Report to Planning and Environment Committee

Subject: Emyv Group Inc.
327 Thompson Road, File Z-9579, Ward 1
Public Participation Meeting

Date: May 23, 2023

Figure 2: Original site concept plan

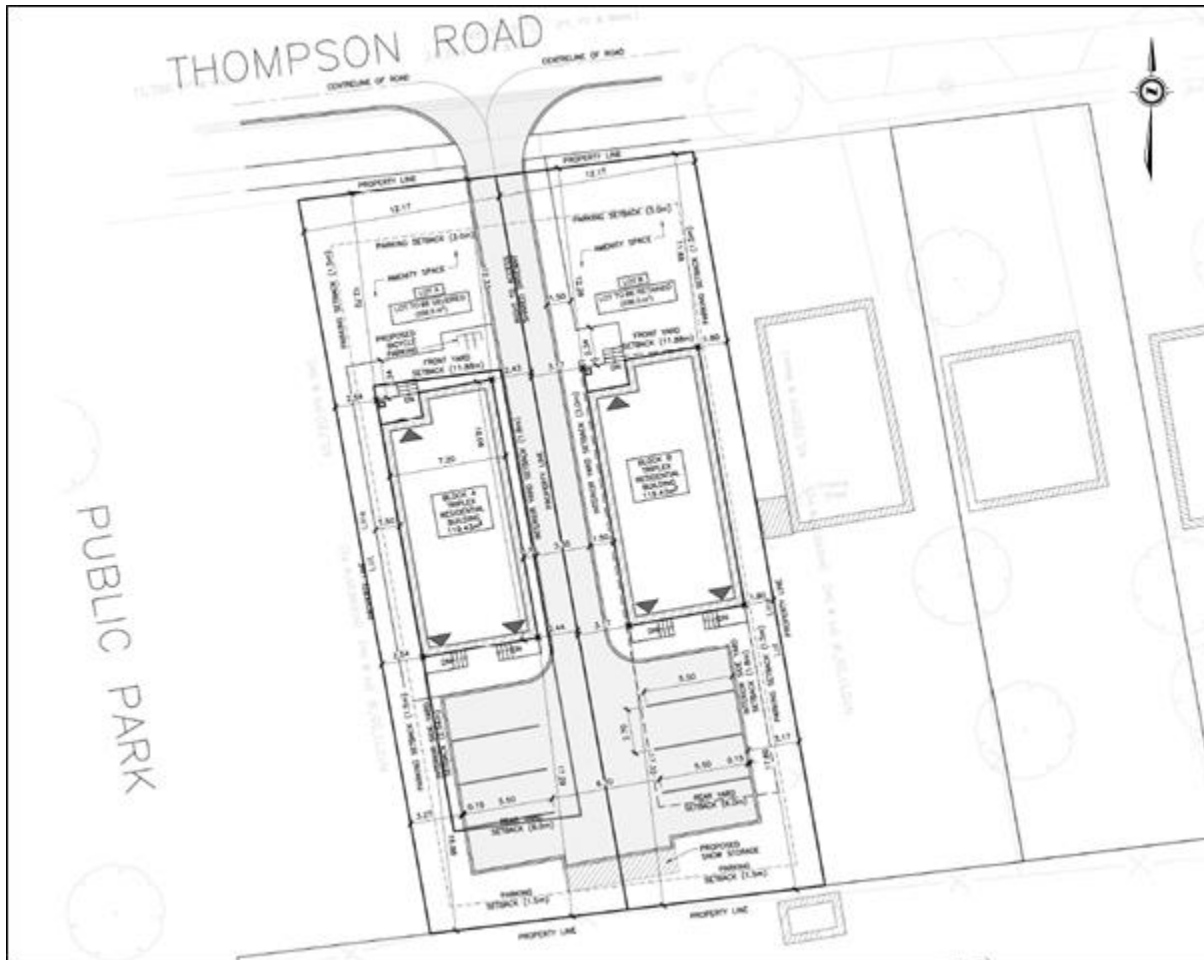
The owner requested to rezone the subject site to facilitate the development of two (2) triplex dwellings on the severed and retained lots. Surface parking would be provided in the rear yard, with access shared between the two properties. The initial site concept proposed a 3.37 metre wide shared access; however, staff raised concern that this access was not wide enough to accommodate two-way traffic. Staff also raised concerns with the lack of a functional and centrally located amenity area for each triplex dwelling, as well as the lack of accessible parking. Figure 2 depicts the original site concept plan as proposed.

- Z.-1 4.23.2: To permit an Interior Side Yard of 2.4 m whereas a minimum of 3.0 m is permitted for Lot A.
- Z.-1 4.19.10.c.i: Consider widening the northern parking spaces from 2.7 metres to 3.4 metres, such as the northeastern space, and shift the rest of the parking down if need be.
- Z.-1 4.21: Clearly illustrate the road allowance on the site plan.
- Z.-1-93172 & Z.-1-041300 – OMB Order 0780 – March 15/06: Please confirm that the total number of bedrooms does not exceed five bedrooms per dwelling.

1. Site Plan Consultation comments apply.
2. They're proposing a 3.35m wide shared access. Transportation is requesting the shared access to be a minimum 6.0m wide in order to accommodate two way traffic. If there is a car pulling in at the same time one is pulling out, we have an issue. A parking space is 2.7m wide, so 3.35m will not accommodate two cars travelling past each other. We want to avoid people backing up on Thompson Road or driving over the front yard.
3. They're not showing the proposed road widening of 2.942m. Not sure if this will impact their zoning in regards to setbacks. We will be taking the widening as part of the consent.

In April 2023, the applicant submitted a revised concept site plan to address staff's concerns with respect to access, accessible parking, and amenity space.

Figure 4: Revised site concept plan

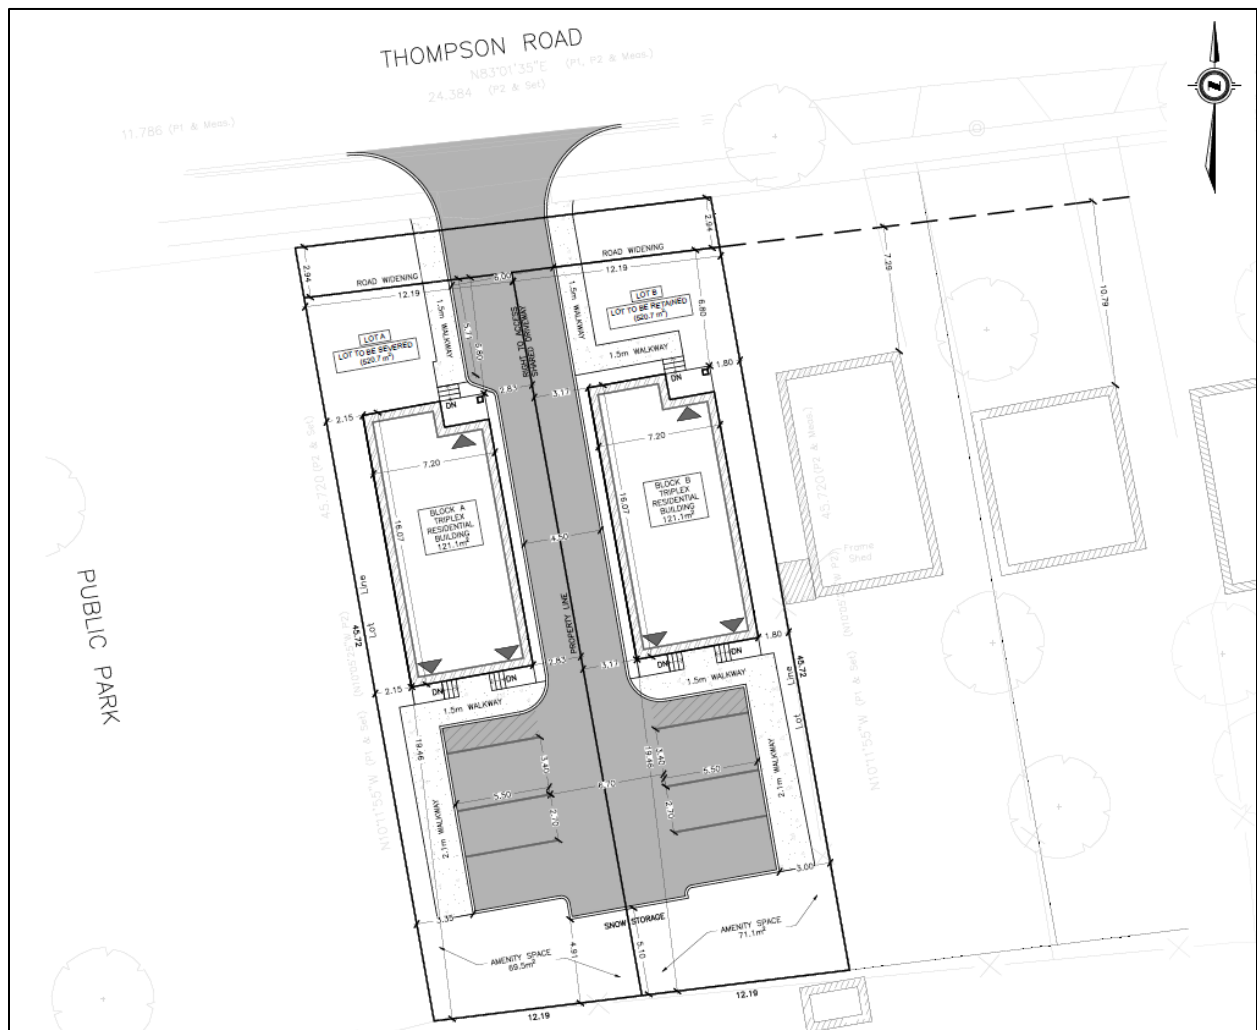
The updated site concept plan includes a designated lay-by area in the front where vehicles entering the site can safely wait for vehicles to exit, should there be a conflict. This avoids potential safety concerns resulting from vehicles backing out of the site onto Thompson Road. The buildings have been shifted closer to Thompson Road, which enables additional amenity space to be provided in the rear yard while maintaining a front yard depth that is consistent with that of neighbouring properties. Lastly, a Type A accessible parking space has been provided on each property.

The revised site concept plan has adequately addressed staff’s concerns regarding site access and driveway width, and provides a larger amenity space at the rear of the property. The current site design shows a front yard depth of 6.8 metres for both triplex dwellings, in accordance with Urban Design staff’s recommended maximum front yard depth of 7 metres. Staff are recommending special provisions for a minimum and maximum front yard depths of 4 and 7 metres, respectively. These setbacks would ensure a consistent street wall is achieved along Thompson Road based on the existing front yard depths of neighbouring properties, as depicted on Figure 4, while also ensuring greater space is provided in the rear yard for a functional outdoor amenity area. Staff are also recommending a special provision requiring minimum interior side and rear yard parking area setbacks of 3 metres (on one side) and 4.9 metres, respectively. The intent of these special provisions is to ensure adequate buffering is provided between the parking area and adjacent properties, and to ensure adequate space is provided in the rear yard for amenity space.

No further comment on this one. They showed the 6.0m access and correct road widening.

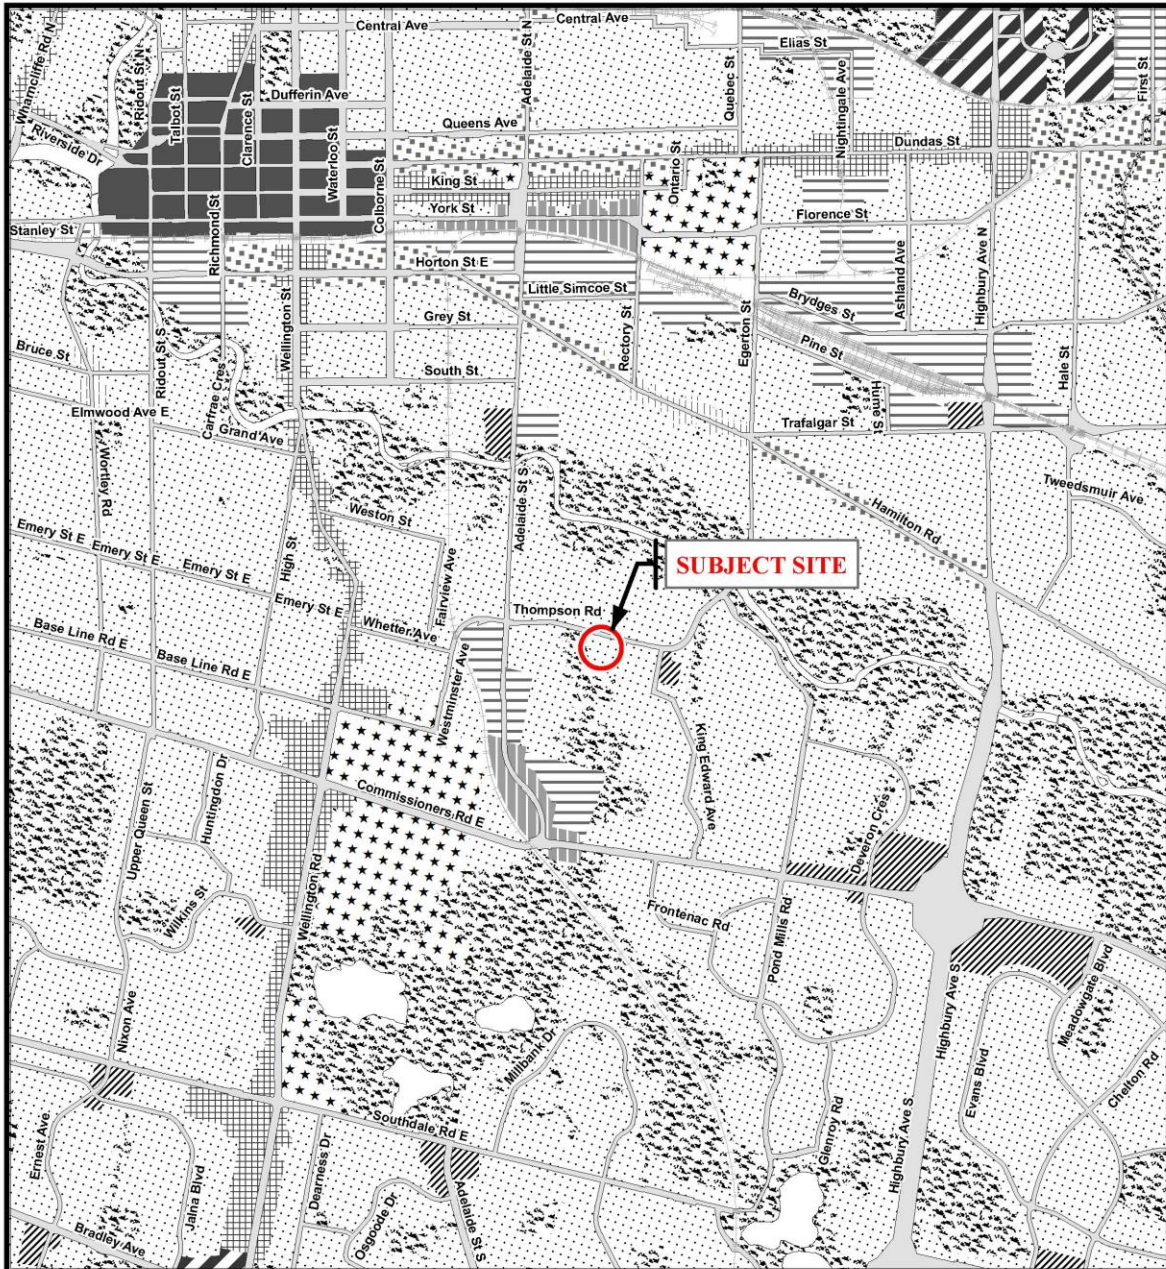
As an ongoing comment, the required interior side yards are 1.2 and 3.0 metres. For setbacks, I round to the specified decimal place in the Zoning By-law. Lot A shows side yard setbacks of 2.15 and 2.83 metres. By shifting the Lot A building 12 centimetres (2.03 and 2.95 metres, rounded to 2.0 and 3.0 metres), this would avoid a deviation from the Zoning By-law without impacting functionalities.

The side yard walkway is a concern for stormwater and landscaping, but other staff can speak to that.

Besides the above, I am mostly satisfied. I'm unsure to what extent this can be ensured without Site Plan Control.
